ADDENDUM NUMBER 3

Thursday, May 3, 2018

PROJECT:
FAIRHOPE LIBRARY ENVELOPE REPAIRS
FAIRHOPE, ALABAMA
GMC PROJECT NO. AMOB170026

1 **REPAIR ROOF PLAN**
A1.00 **SCALE: 3/32" = 1'-0"**

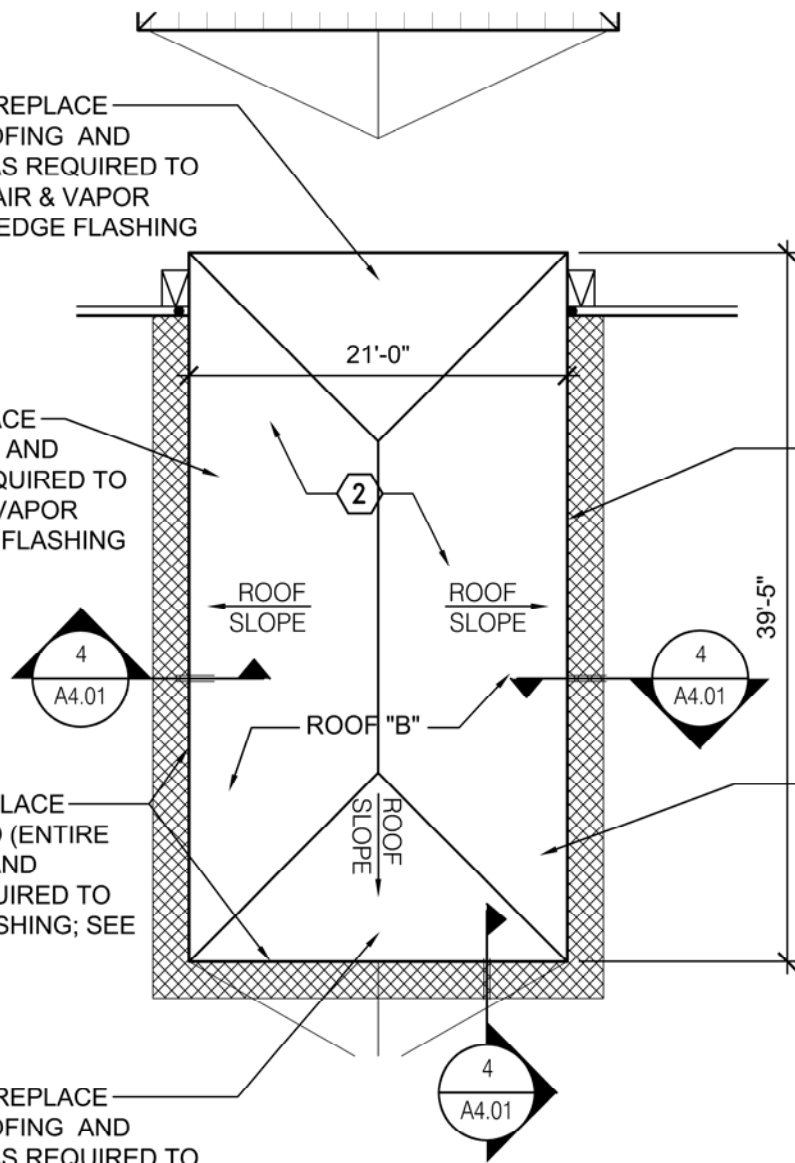
A. Sheet D1.00; Roof "B". Remove existing stucco system on the south, east and west walls in its entirety. Provide and install new air and vapor barrier over existing exterior sheathing and new stucco system including lath, flashing and all accessories. See Attached ASD-01

REMOVE AND REPLACE EXISTING ROOFING AND EDGE METAL AS REQUIRED TO INSTALL NEW AIR & VAPOR BARRIER AND EDGE FLASHING

REMOVE AND REPLACE EXISTING STUCCO (ENTIRE WALL SURFACE) AND ROOFING AS REQUIRED TO INSTALL NEW FLASHING; SEE DETAIL 4/A4.01

REMOVE AND REPLACE EXISTING STUCCO (ENTIRE WALL SURFACE) AND ROOFING AS REQUIRED TO INSTALL NEW FLASHING; SEE DETAIL 4/A4.01

REMOVE AND REPLACE EXISTING ROOFING AND EDGE METAL AS REQUIRED TO INSTALL NEW AIR & VAPOR BARRIER AND EDGE FLASHING

REMOVE AND REPLACE EXISTING ROOFING AND EDGE METAL AS REQUIRED TO INSTALL NEW AIR & VAPOR BARRIER AND EDGE FLASHING

Round Curtain Wall Window Opening

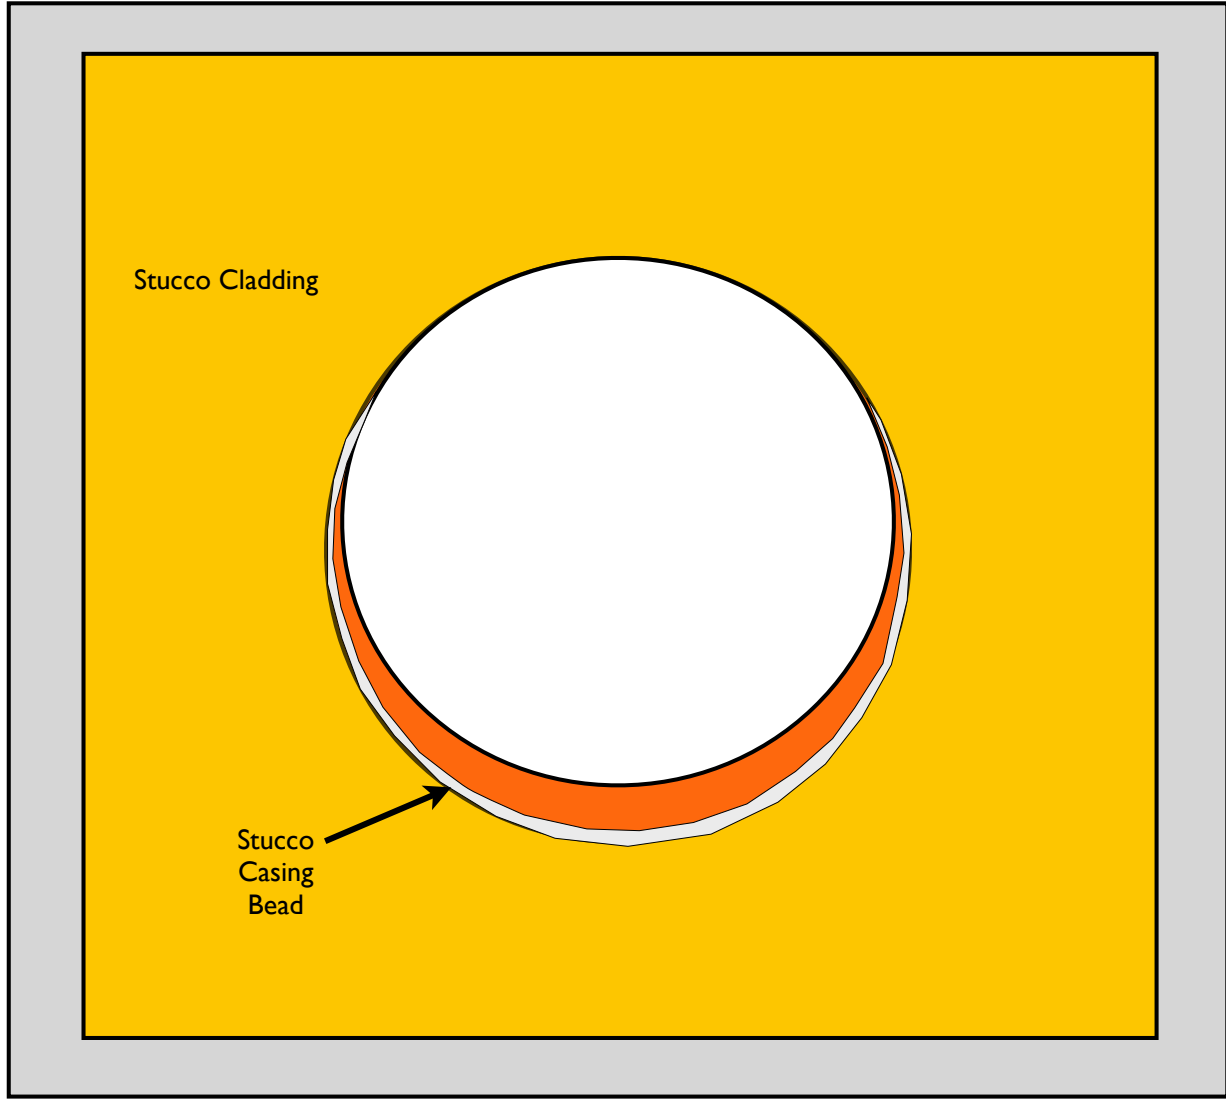
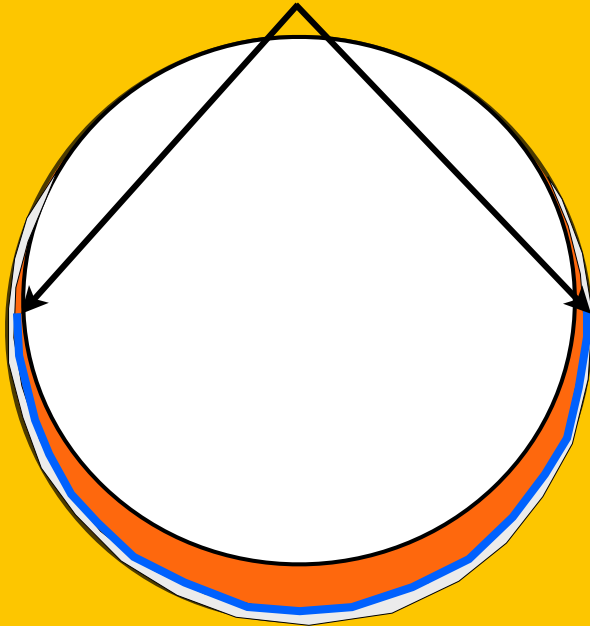
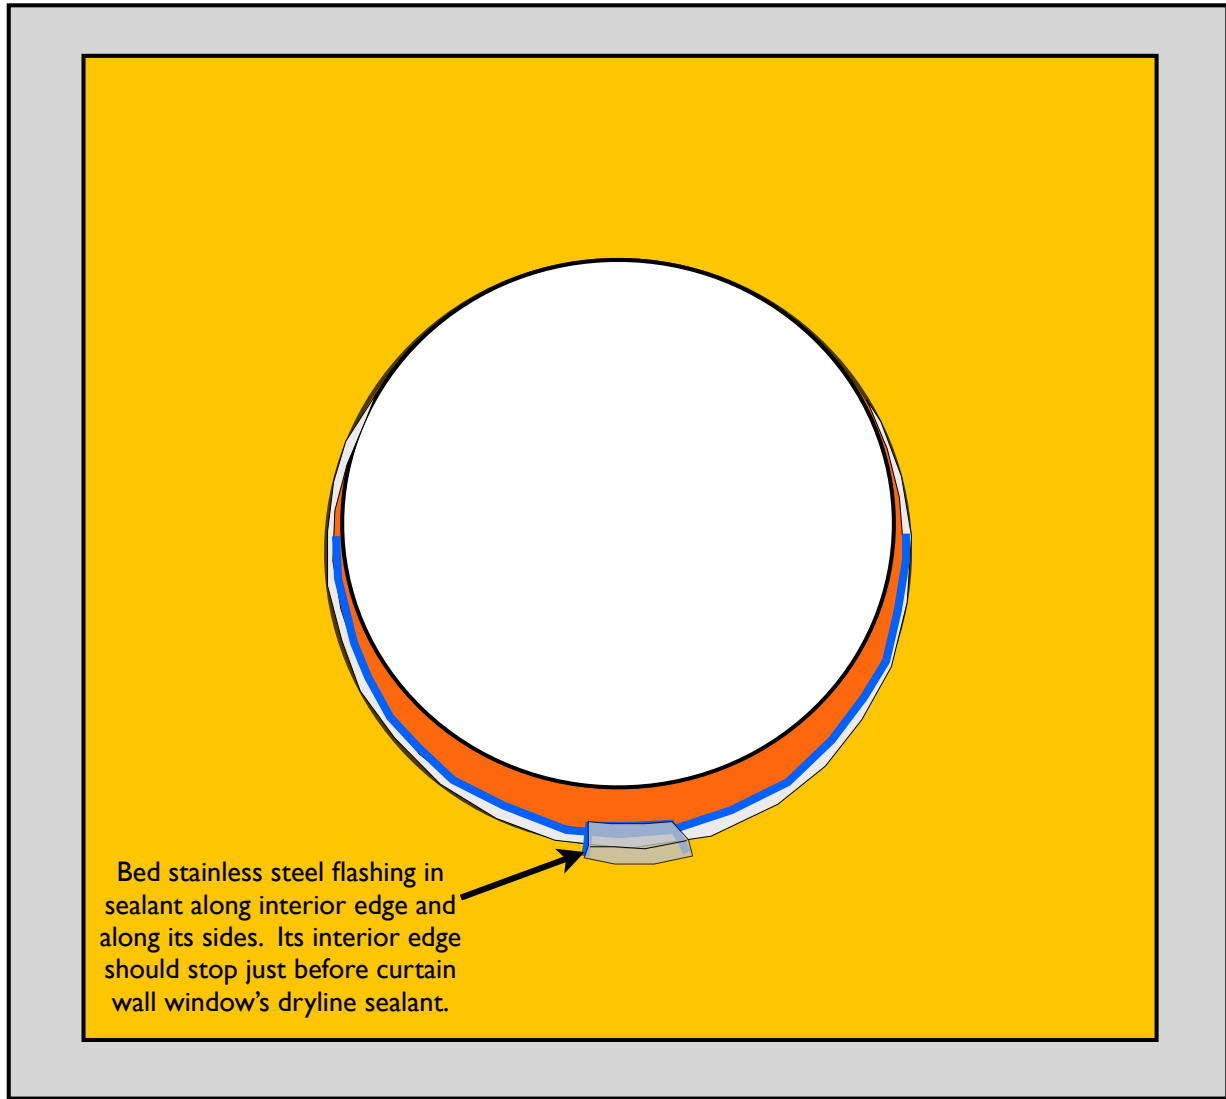
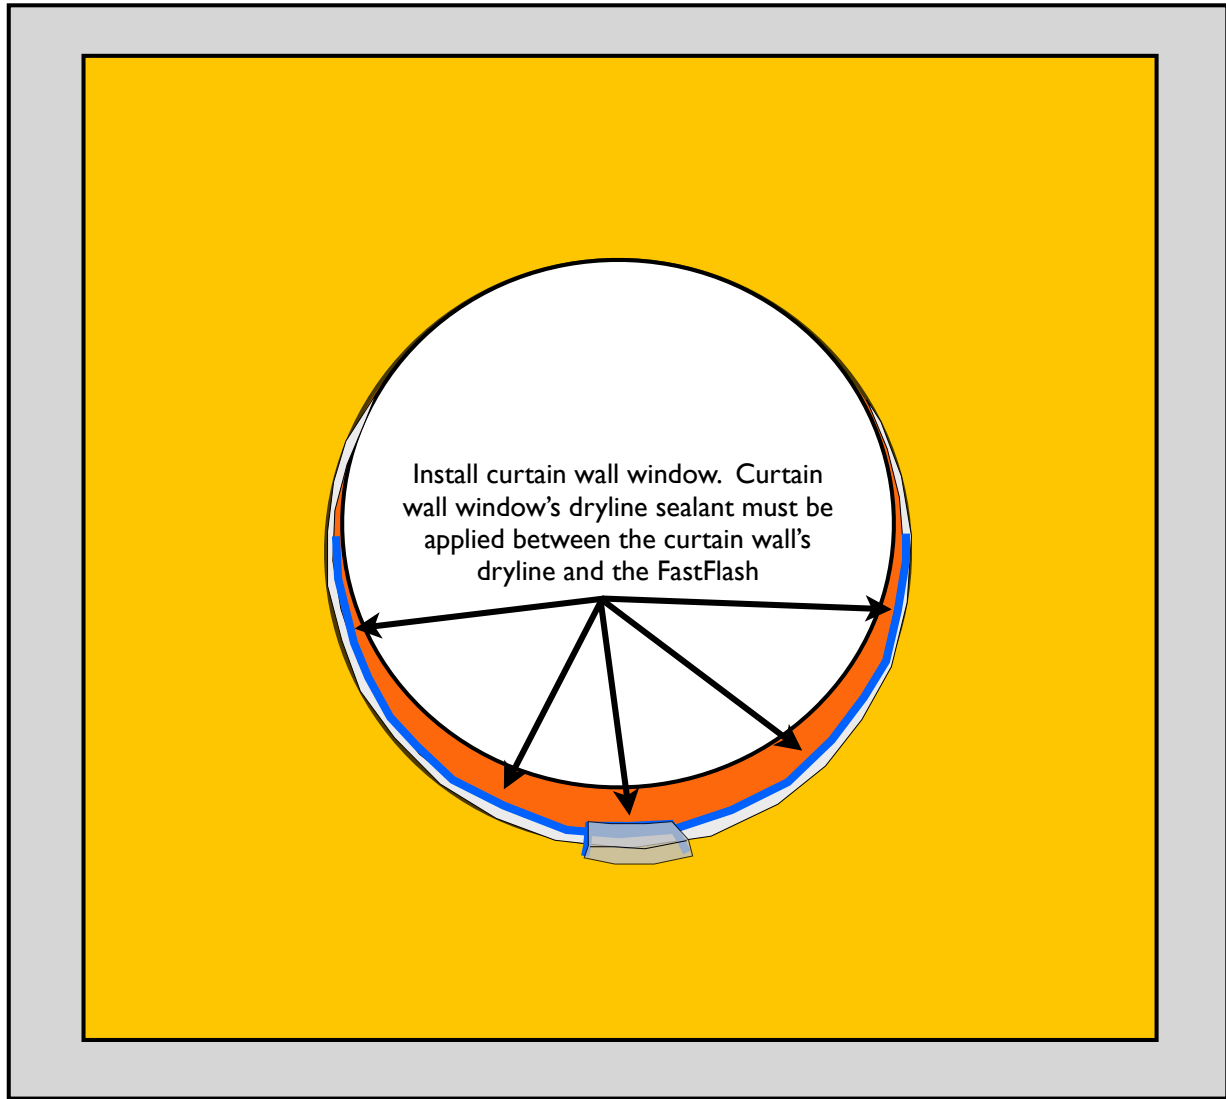
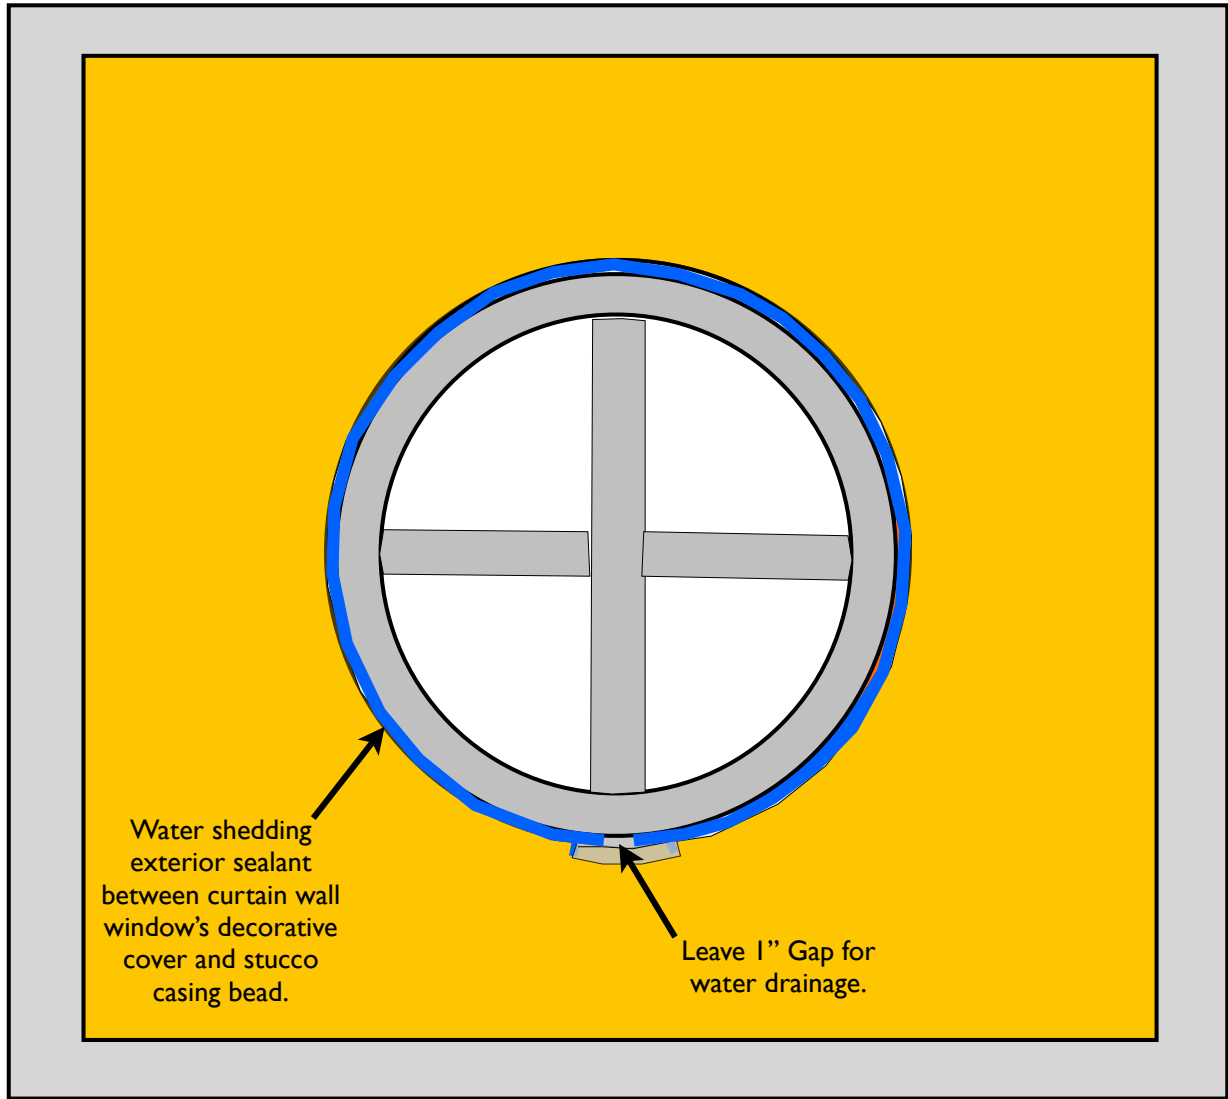
Answer: Remove Section 07563, 1.11, D. Does not apply.
- D. Please confirm that all 6 windows as noted to be removed on 3/D2.00 are to be replaced with new storefront windows. 3/A2.00 calls for only 4 of them to be replaced.

Answer: The (4) rectangular windows are to be removed and replaced with new storefront window systems. The (1) round window above the stairway is to be removed, stored, and reinstalled at a higher level. The remaining round windows can remain in place, but a continuous envelope water tight seal system will have to be repaired back to the window dry line. Repairing the water / air barrier envelope system will require the stucco around the window to be removed, felt pulled back,

and liquid flashing membrane fully adhered back to the existing water / air barrier system (Tyvek) to provide a continuous water tight seal for the building envelope.

Proscos FastFlash
applied into window
opening and onto
face of wall

Seal between stucco casing
bead and FastFlash at lower
half of window opening

Water shedding exterior sealant between curtain wall window's decorative cover and stucco casing bead.

Leave 1" Gap for water drainage.
